May 9, 2023

ADDENDUM NO. 1

RE: Item #1, May 17, 2023 Letting - NH 0018(157)438, PCN 6923, Lincoln County - Grading, PCC Surfacing, Asphalt Concrete Surfacing & Replace Str RCBC (2 - 9'x5' Precast or CIP; 2 - 12'x5' CIP RCBC)

| | NH 0018(157)438 | Z4 | Z19 |

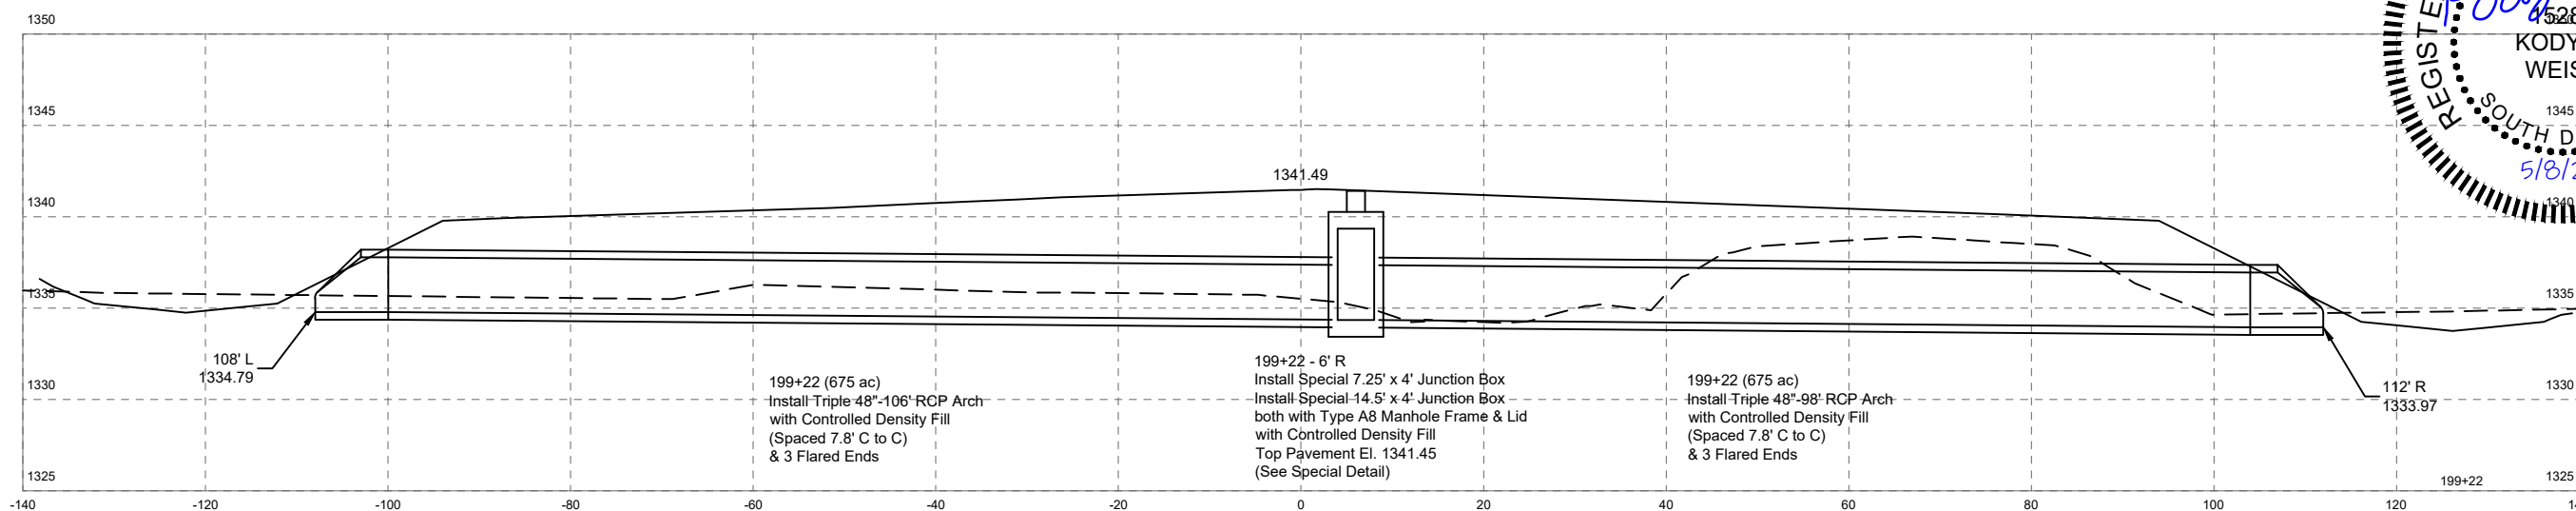
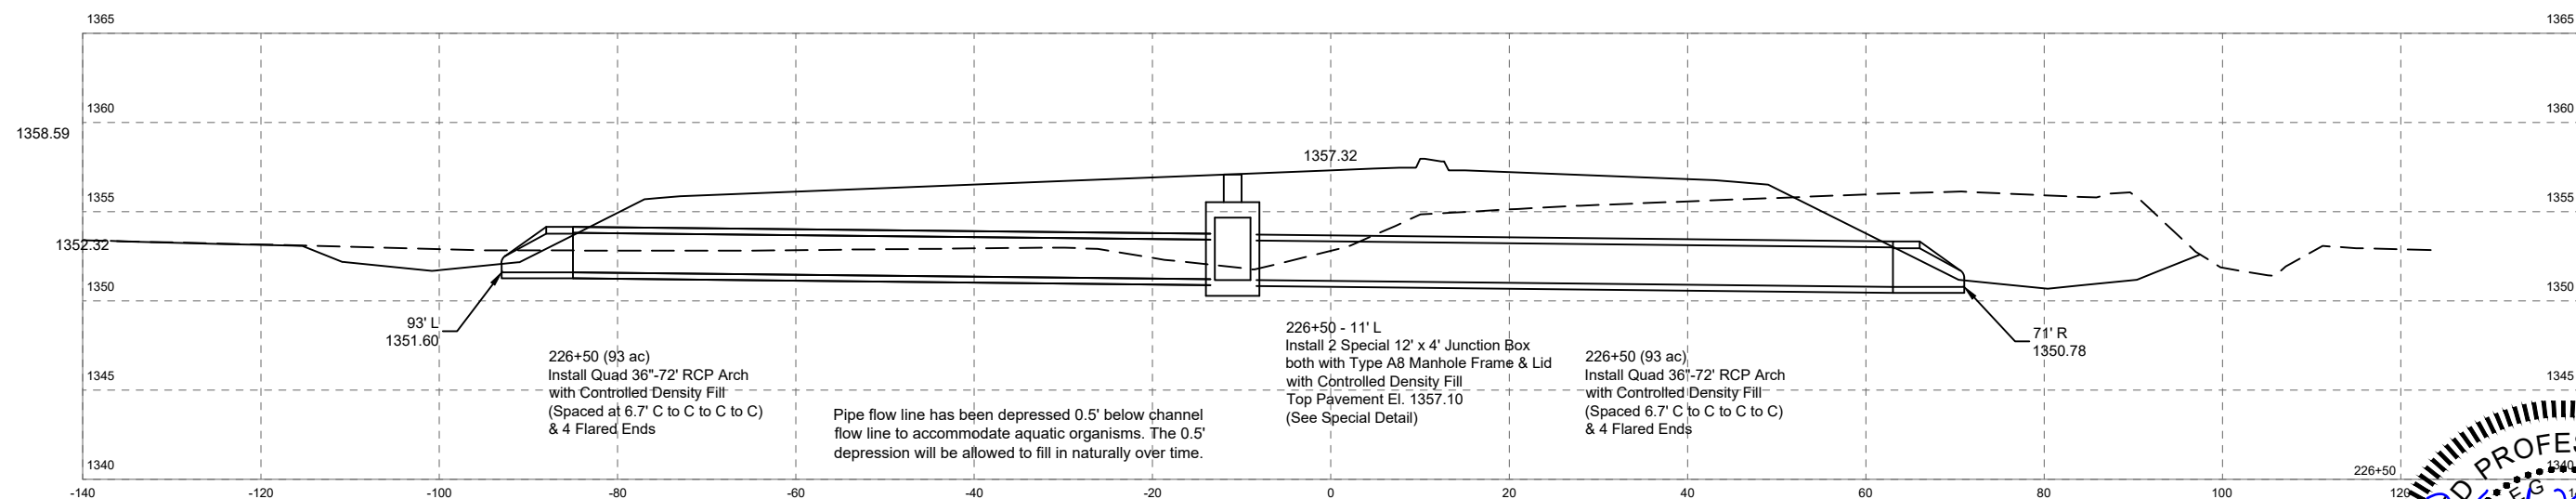
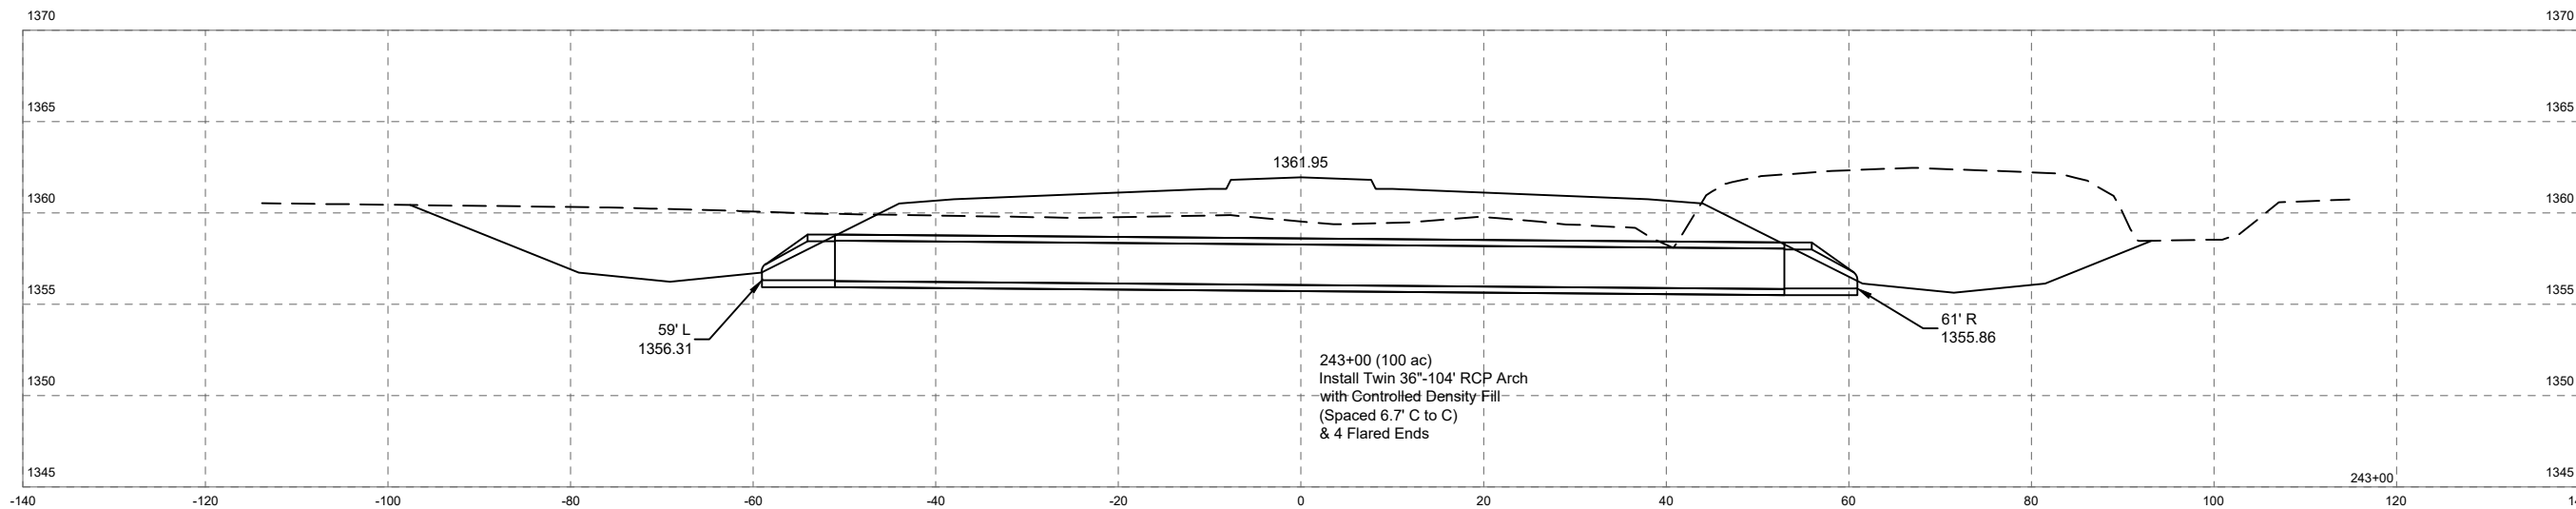
- Sheets X55 & X56:** Curb & Gutter on right was removed from Sta 325+00 to Sta 330+00.
- Sheets Z3, Z4, Z6 & Z7:** Junction Box notes were revised.
- Sheet Z14:** Drop Inlet at Sta 324+20.62 was removed. Pipe at Sta 308+17R was added.
